UNITED STATES DEPARTMENT OF COMMERCE United States Patent and Trademark Office Address: COMMISSIONER FOR PATENTS P.O. Box 1450 Alexandria, Virginia 22313-1450 www.uspto.gov

APPLICATION NO.	FILING DATE	FIRST NAMED INVENTOR	ATTORNEY DOCKET NO.	CONFIRMATION NO.
10/554,267	10/24/2005	Yoshinari Takemura	59349.00043	2724
32294 7590 12/12/2007 SQUIRE, SANDERS & DEMPSEY L.L.P. 14TH FLOOR			EXAMINER	
			ARCE DIAZ, MARLON A	
8000 TOWERS CRESCENT TYSONS CORNER, VA 22182			ART UNIT	PAPER NUMBER
			3611	
			MAIL DATE	DELIVERY MODE
			12/12/2007	PAPER

DETAILED ACTION

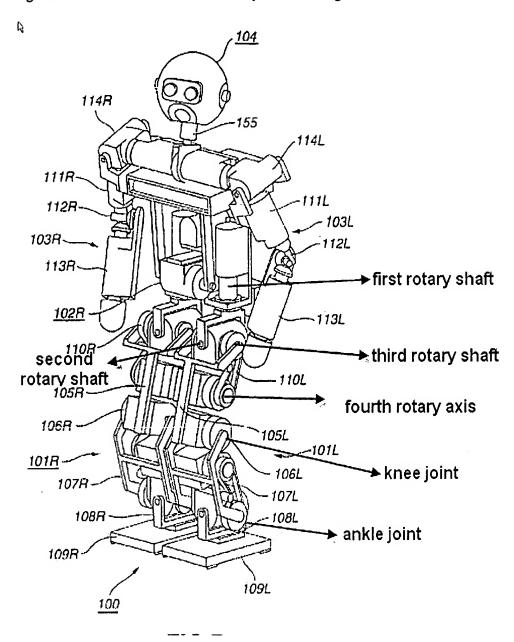
- 2. Claims 1,3,4,13 and 14 are rejected under 35 U.S.C. 102(e) as being anticipated by Hattori (US 6802382). Hattori discloses a robot moving on legs and control method comprising: a robot comprising a hip joint (Fig below) with a first rotary shaft (Fig below) that is the hip yaw axis (16), a second rotary shaft (Fig below) that is the hip roll axis (18), a third rotary shaft (Fig below) that is the hip pitch axis (17) and a fourth rotary Shaft (Fig below) that results in a degree of freedom; Hattori further discloses a knew joint (Fig below) and an ankle joint (Fig below). {{Examiner likes to point out that the figure seen below is indeed figure 7 in Hattori's}}. Regarding claim 3, the fourth rotary

shaft is in not parallel to the yaw axis as seen below. Regarding claim 4, the fourth rotary shaft is placed forwardly of the first shaft as seen in figure 8. Regarding claim 13, figure 8 also shows the first rotary shaft being offset in the direction of the roll axis.
